**STEBENVILLE CITY SCHOOLS
HIGH SCHOOL ENTRY / CLASSROOM RENOVATION****TO: ALL BIDDERS**

END OF ADDENDUM TWO

STUEBENVILLE HIGH SCHOOL STEM BUILDING

PROJECT NO.
21042.000

M1-2

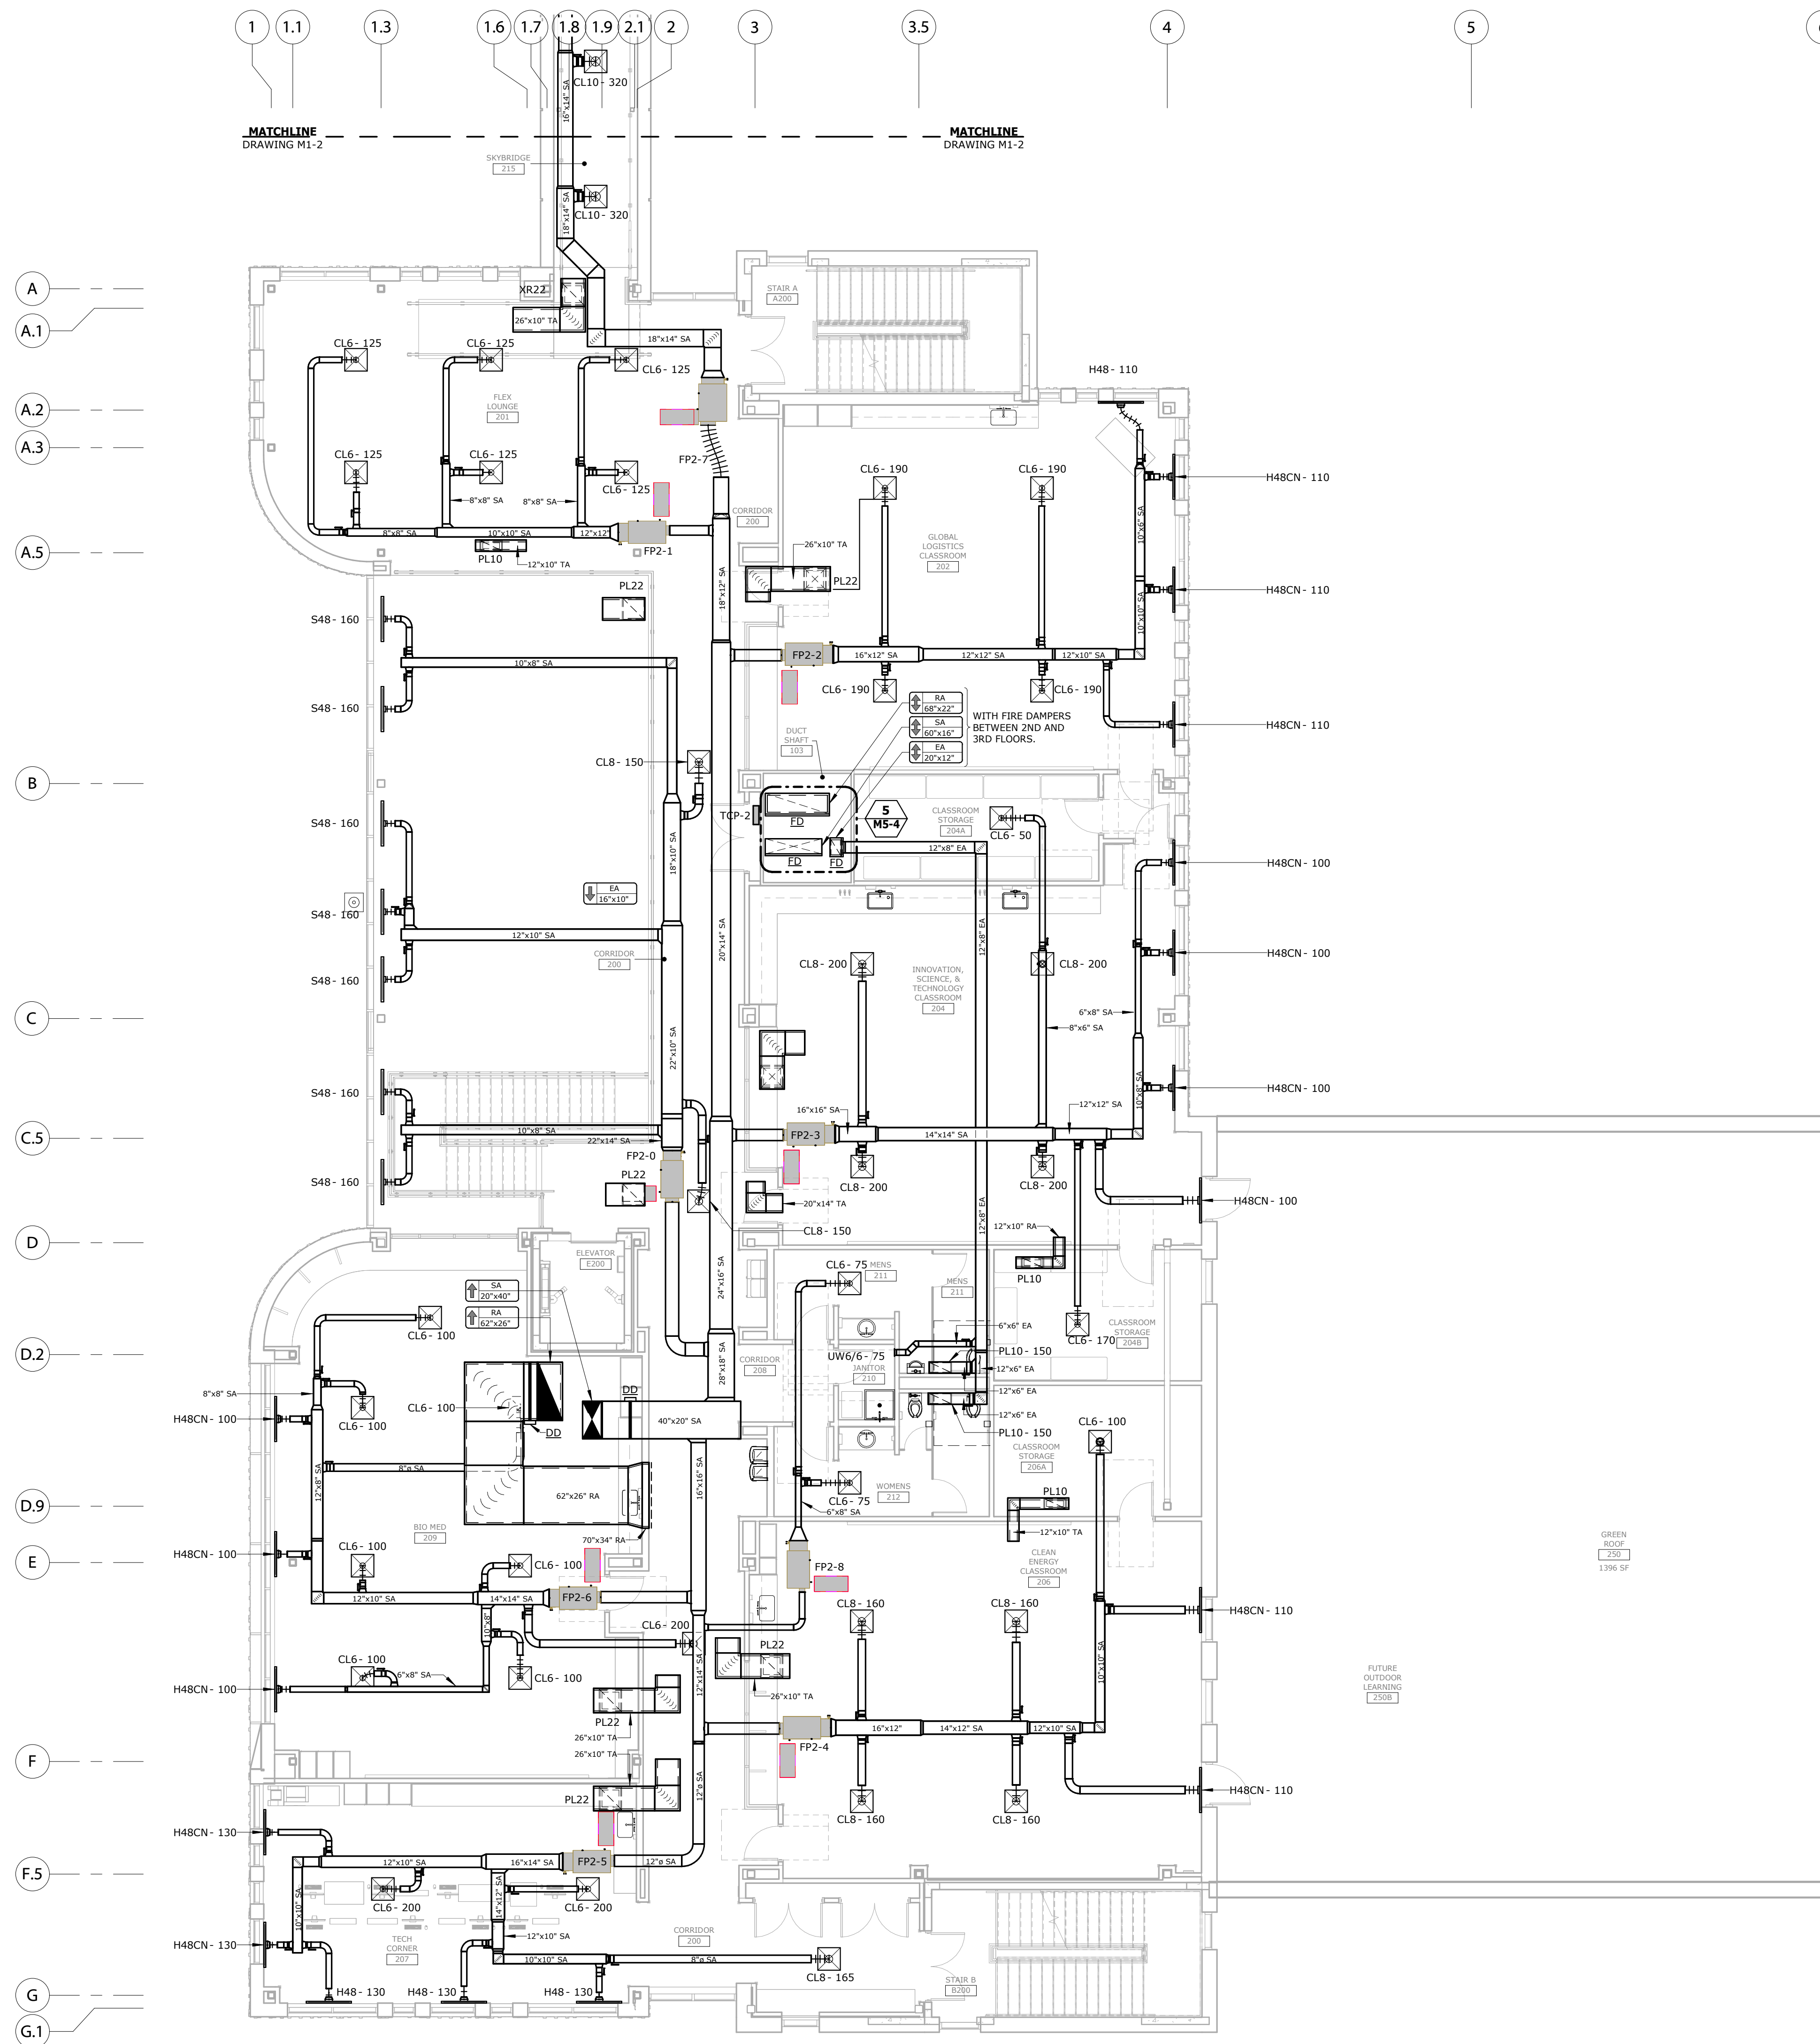
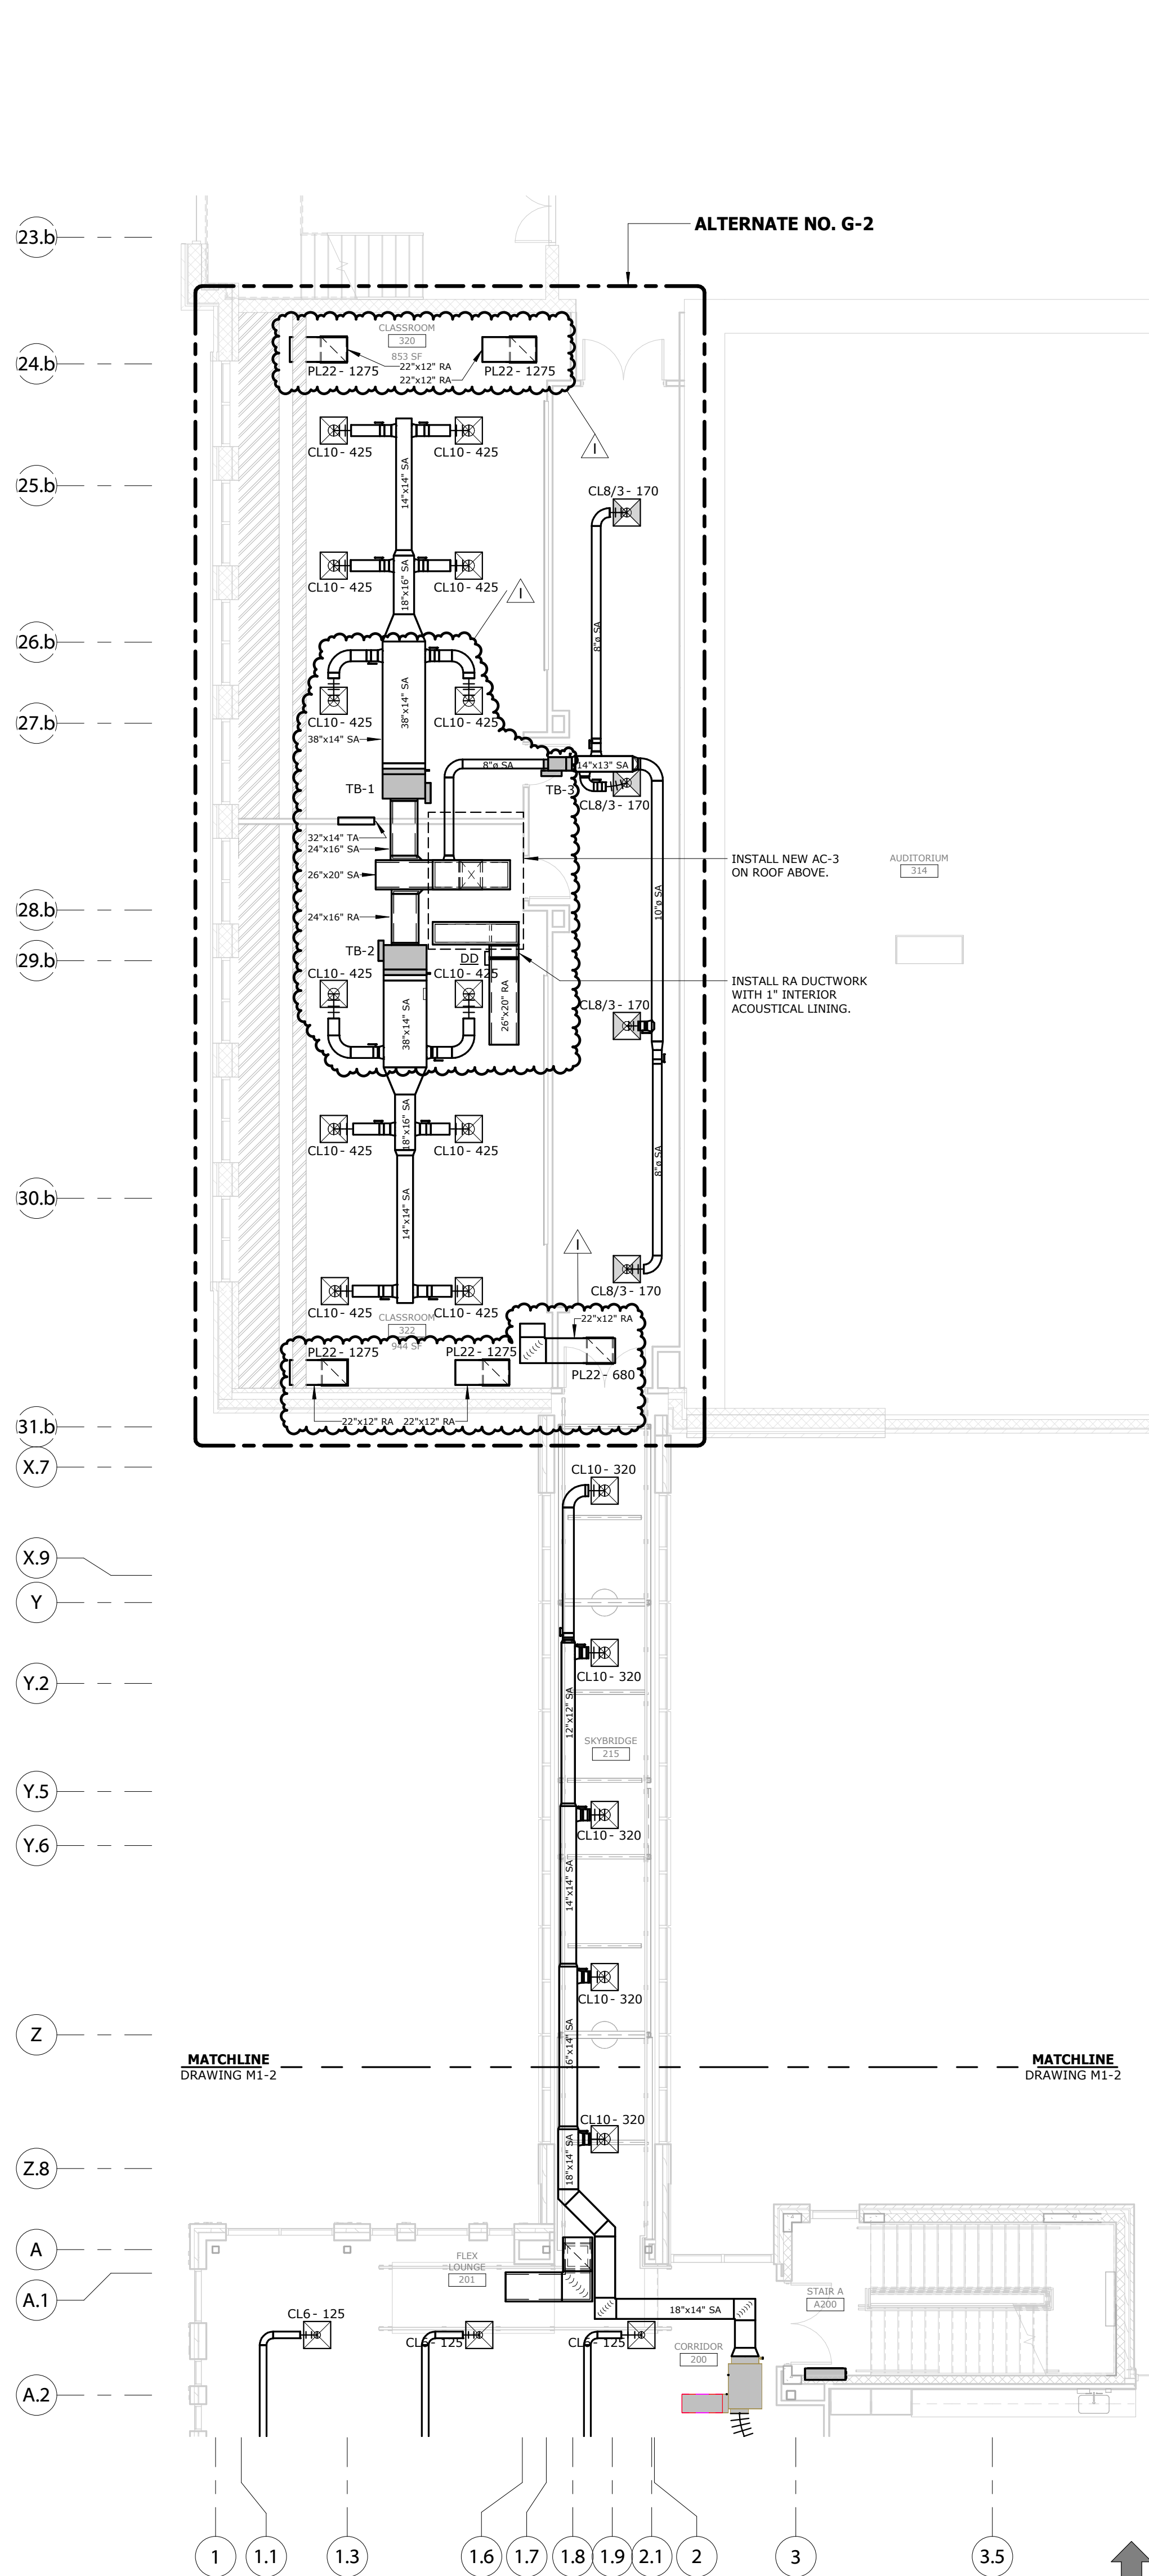
1. Drawing M1-2
 - a. Modified VAV box sizes.
 - b. Added transfer air opening.
 - c. Added return boots to return grilles.
 - d. Add acoustical lining to SA / RA off RTU.
 - e. Added elbow to corridor return.
 - f. Modified duct routing and sizes
2. Drawing M5-6
 - a. Updated VAV box schedule
 - b. Updated RTU schedule
3. Drawing E3-2
 - a. Modified disconnect fuse size.
